CHANGE ORDER

PROJECT: **JOG ROAD/N. OF SR-710 TO N. OF**
 (Name) **FLORIDA'S TURNPIKE**
 TO:
 (Contractor) J.W. Cheatham, LLC

CHANGE ORDER NO: 3 (three)
 COUNTY PROJECT NO: 2009500
 CONTRACT DATE: 08/14/12
 RESOLUTION NO: R2012-1077
 DISTRICT NO: 1

Modify concrete retaining wall as per plan revision no. 3 sheets BW-1, BW-6, BW-6A, BW-7, and BW-11. Work includes form rental, setting and removing, forms previously placed, saw cutting, chipping previously placed concrete, re-surveying, additional bond cost, additional M.O.T., and overhead – Lump Sum

SHEET BW-6	PROJECT NO. 11-567
---------------	-----------------------

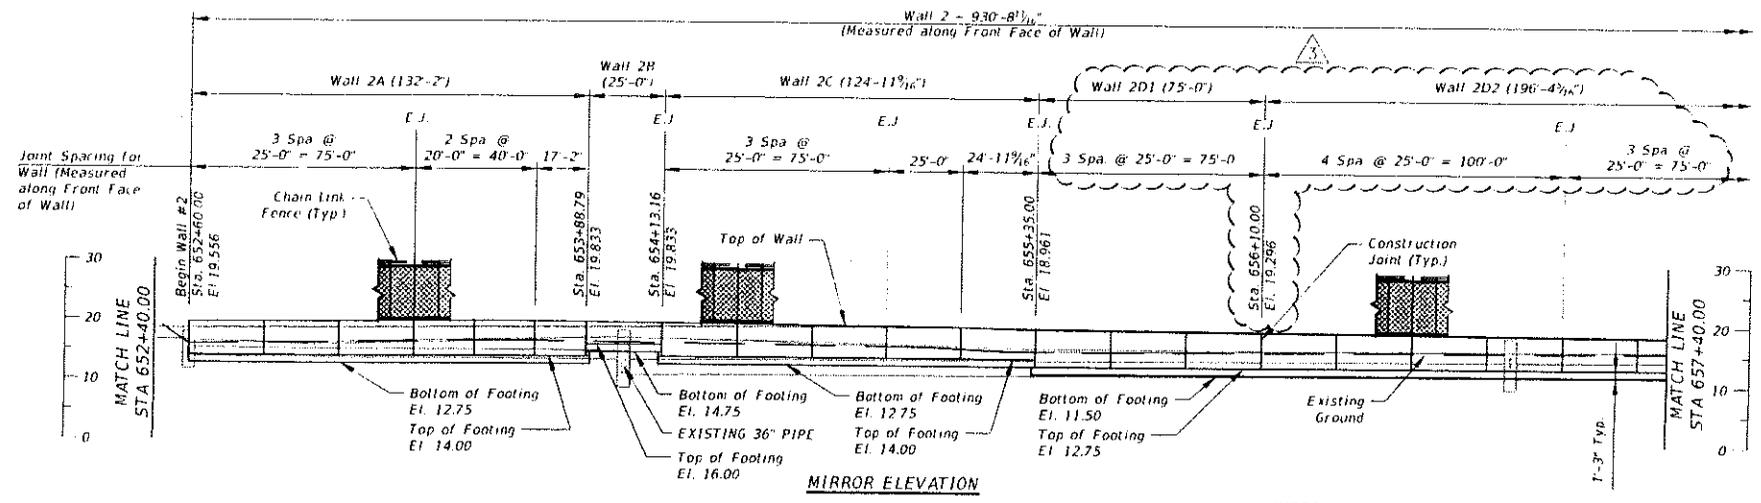
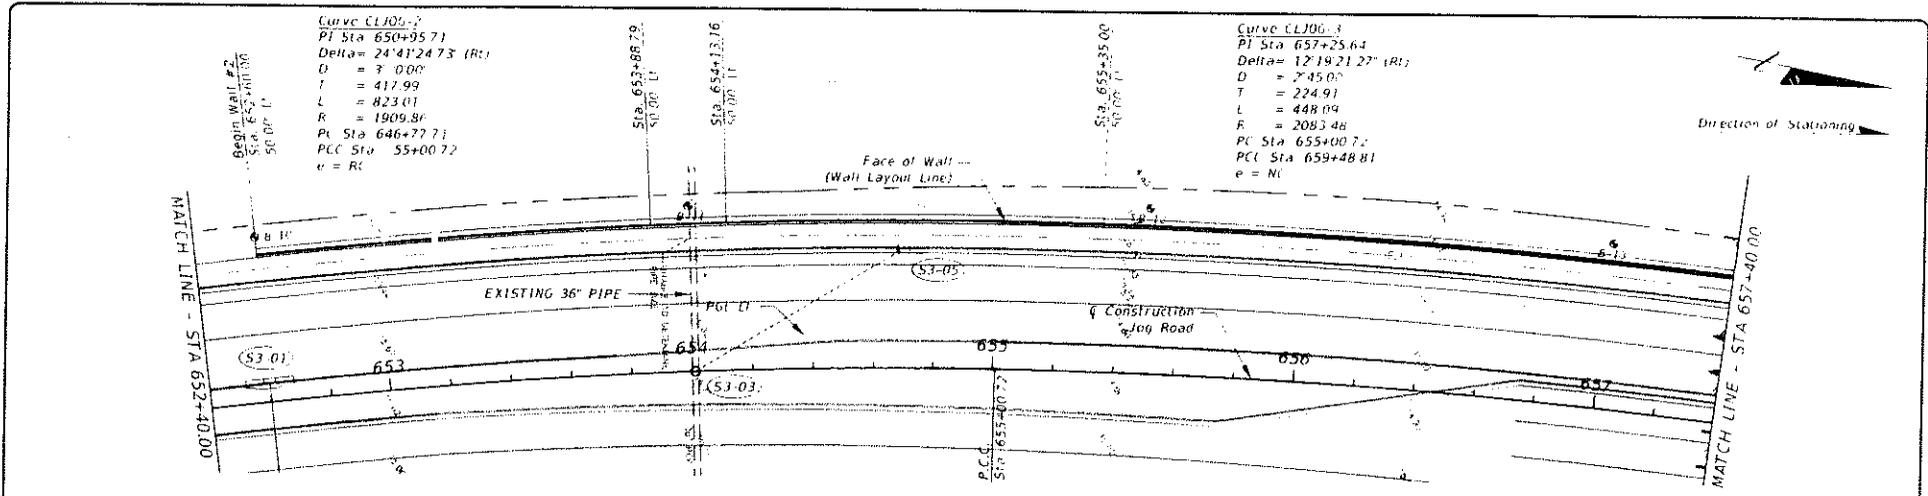
Because Wantman Group did not give the final PGL elevations to the structural engineer, the structural plans for construction of the northernmost sections of the west wall given to the contractor were incorrect, resulting in the wall plan revisions and reconstruction. The cost for this work should be classified as "Errors and Omissions" when the change order is written up by Construction Coordination.
